SERIAL: BSEP 01-0041

BRUNSWICK STEAM ELECTRIC PLANT, UNIT NOS. 1 AND 2
DOCKET NOS. 50-325 AND 50-324/LICENSE NOS. DPR-71 AND DPR-62
REVISIONS TO PLANT EMERGENCY PROCEDURES

Summary of Revisions

Control Room Emergency Communicator Flow Chart

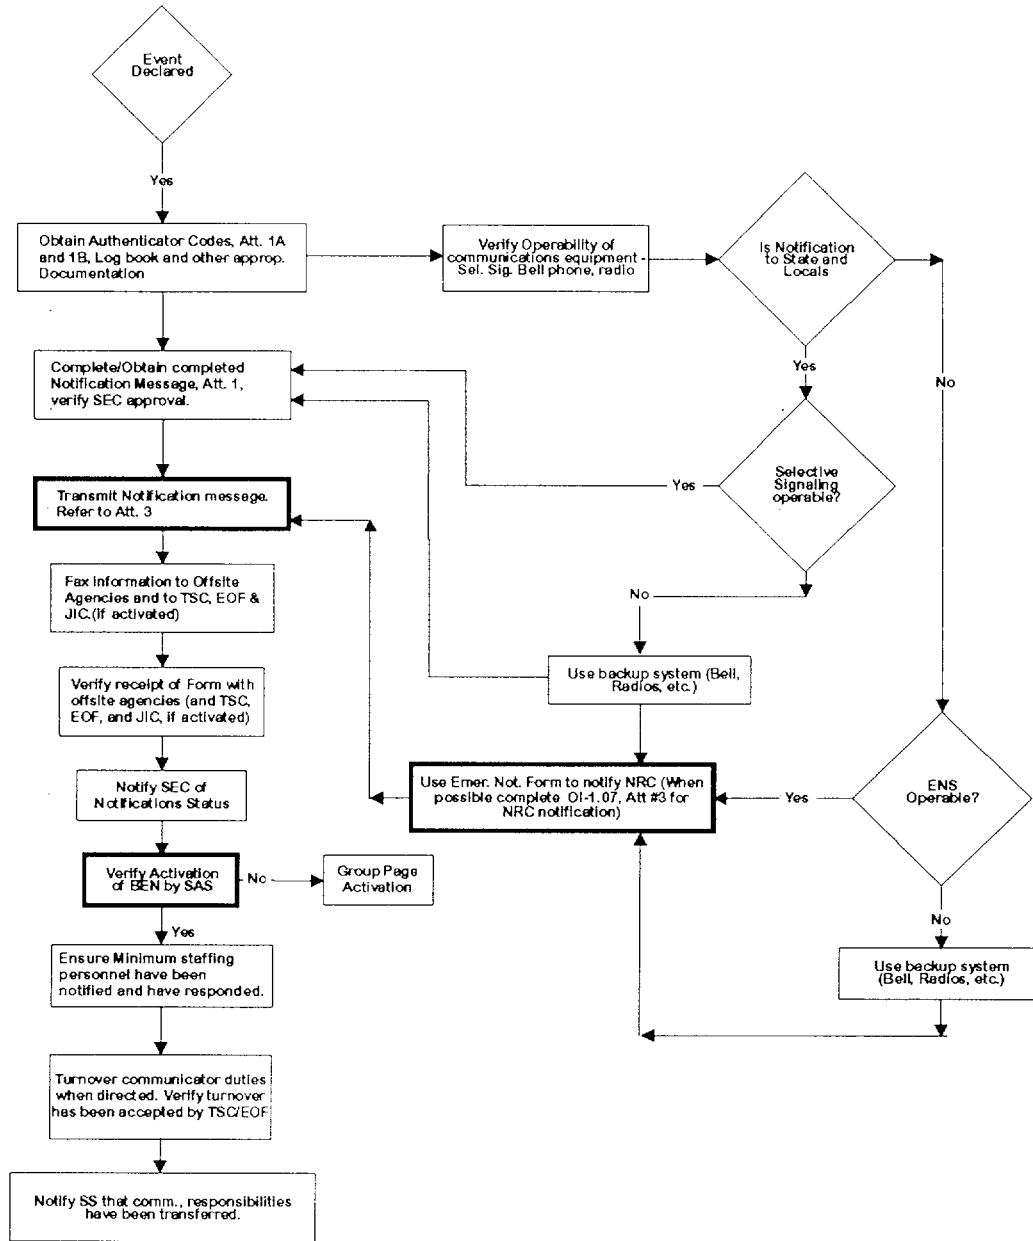
5. Removed a reference to FTS-2000 telephones in Attachment 3 to reflect changes to the Emergency Telecommunications System;
 6. Revised Attachment 6, "Control Room Emergency Communicator Flow Chart," to correct the flow chart processes; and

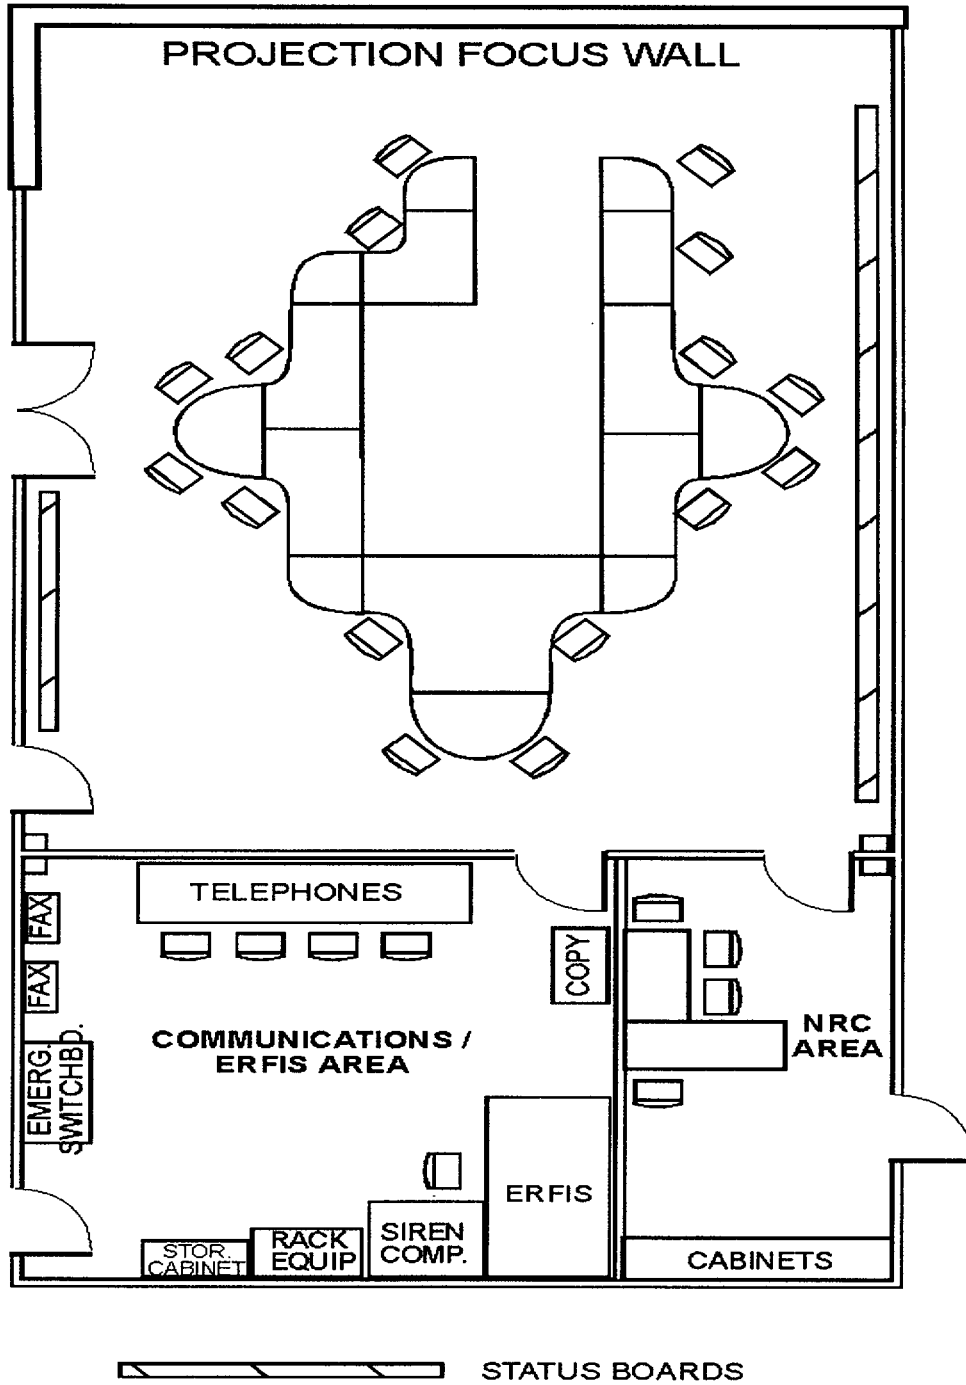
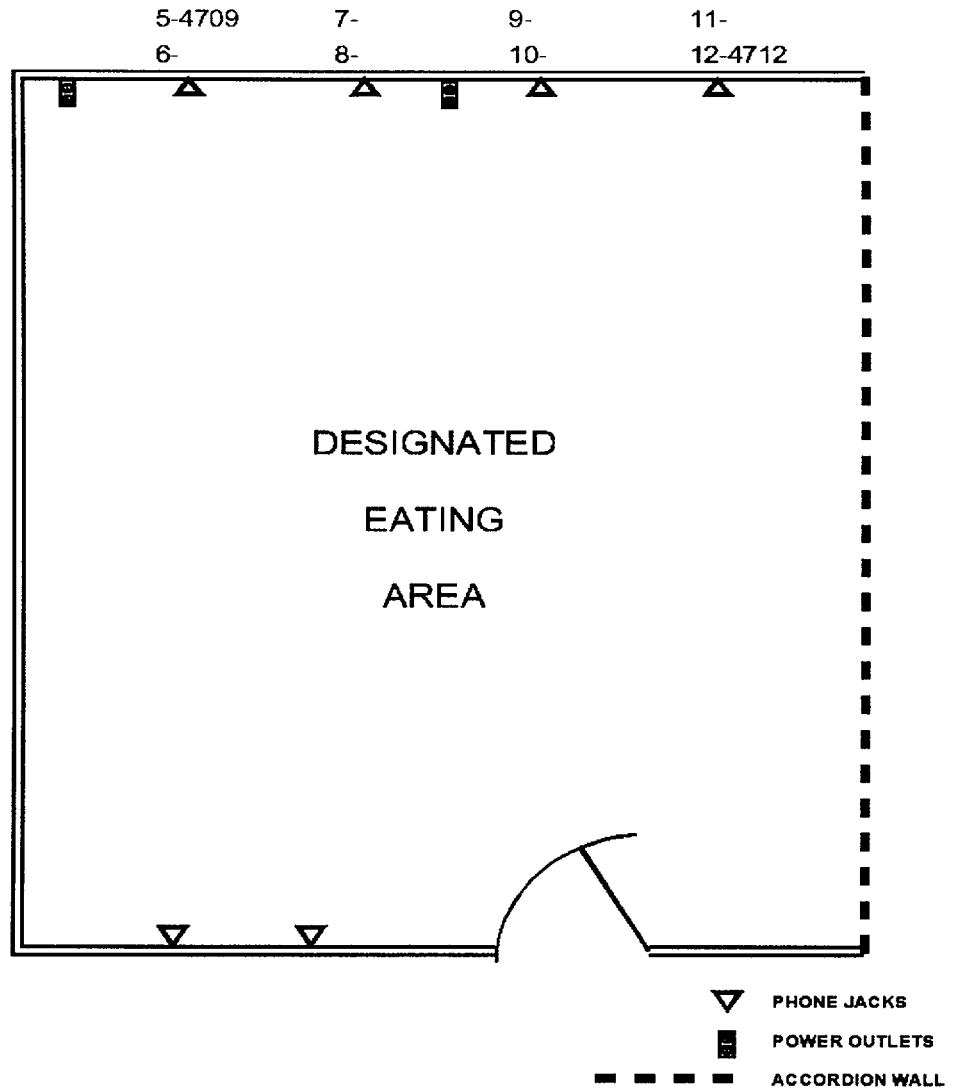
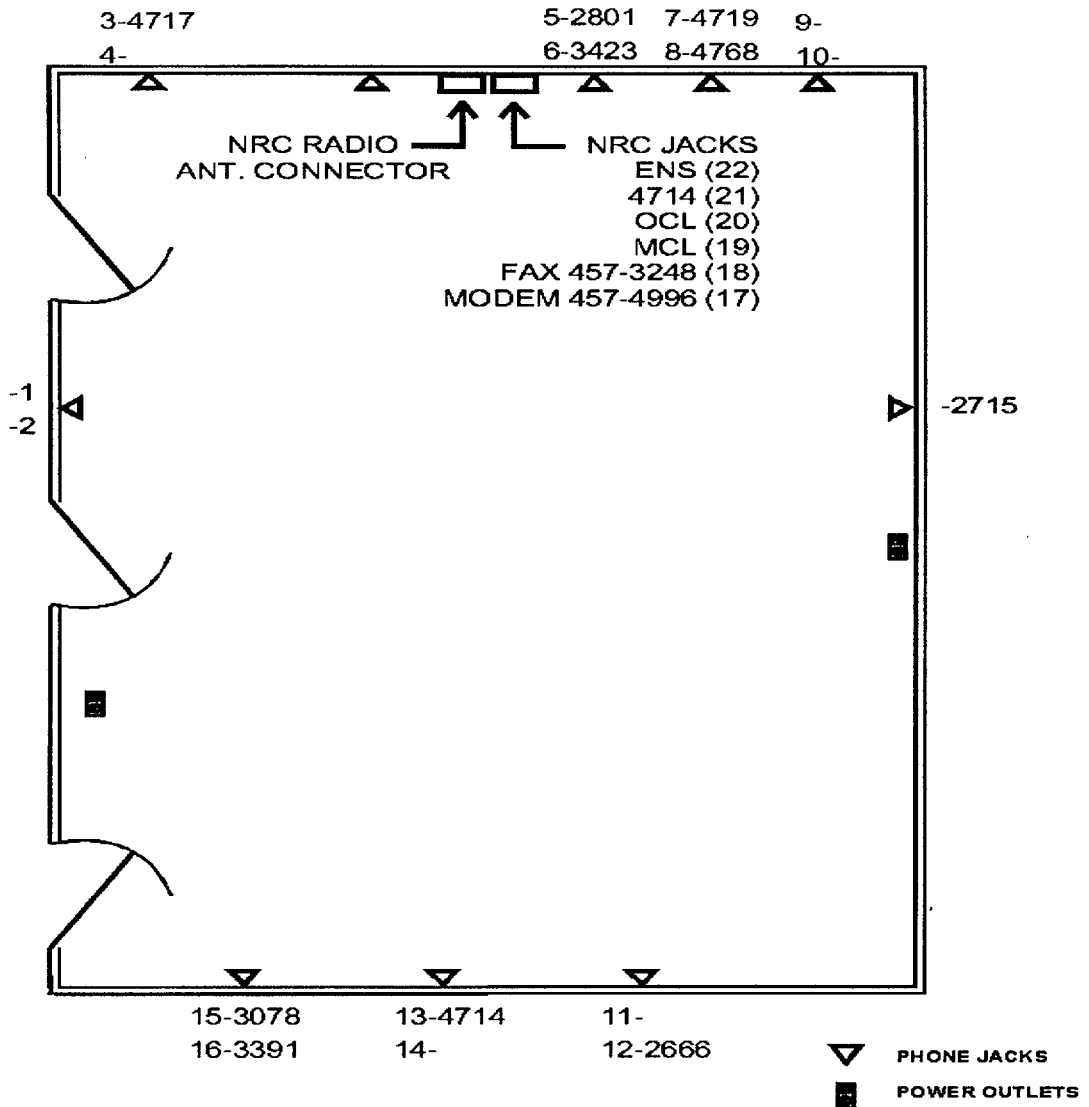
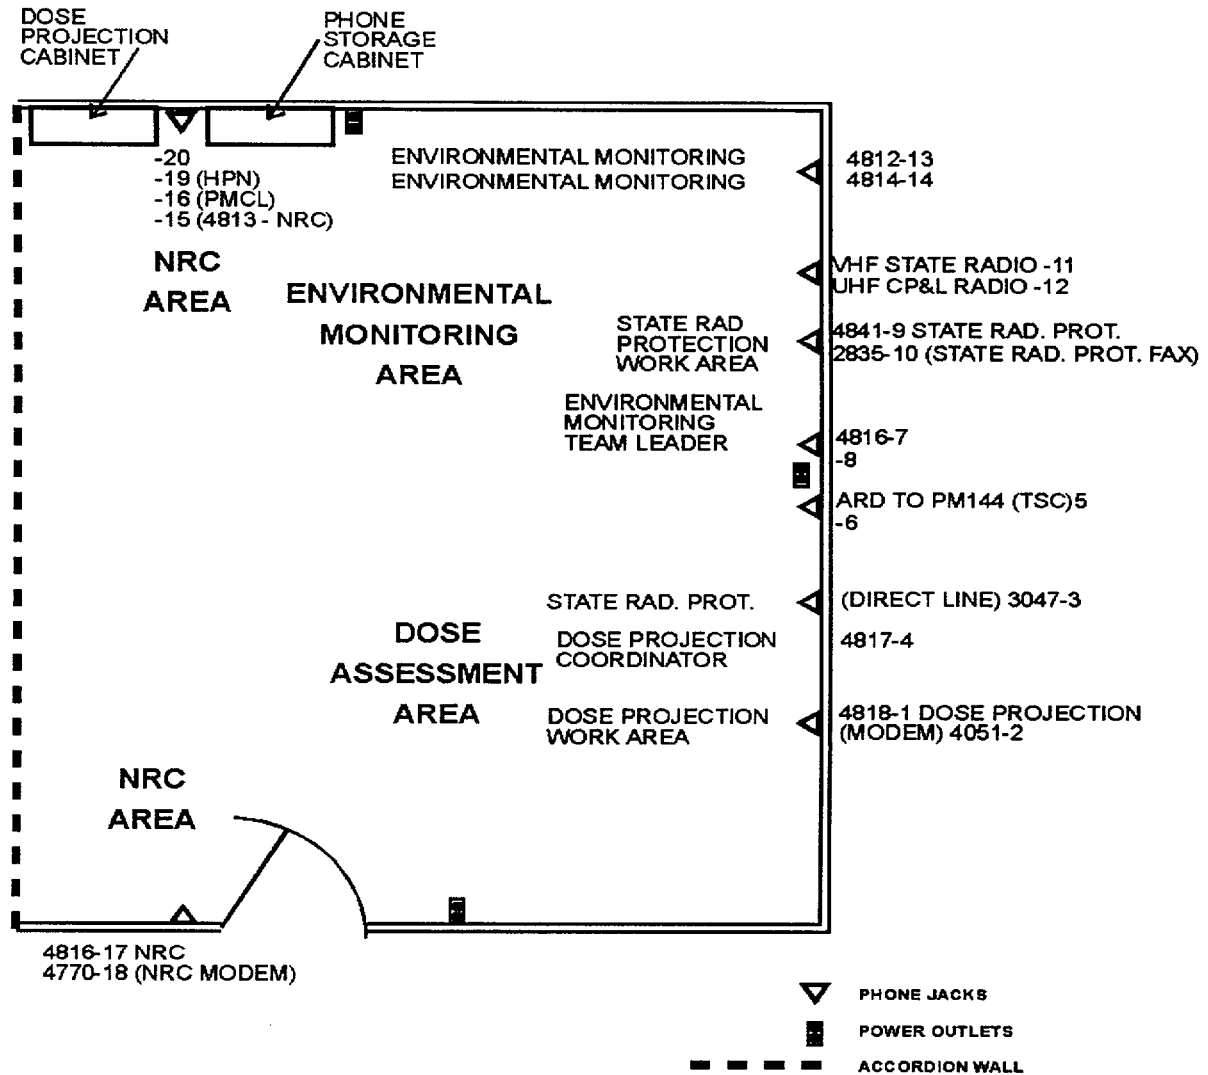
4. Revised Section 5.14.8 to provide additional guidance for the HPN Communicator when making NRC notifications;
 5. Revised Attachments 2, 3, 4, and 5 to reflect changes in the EOF layout; and
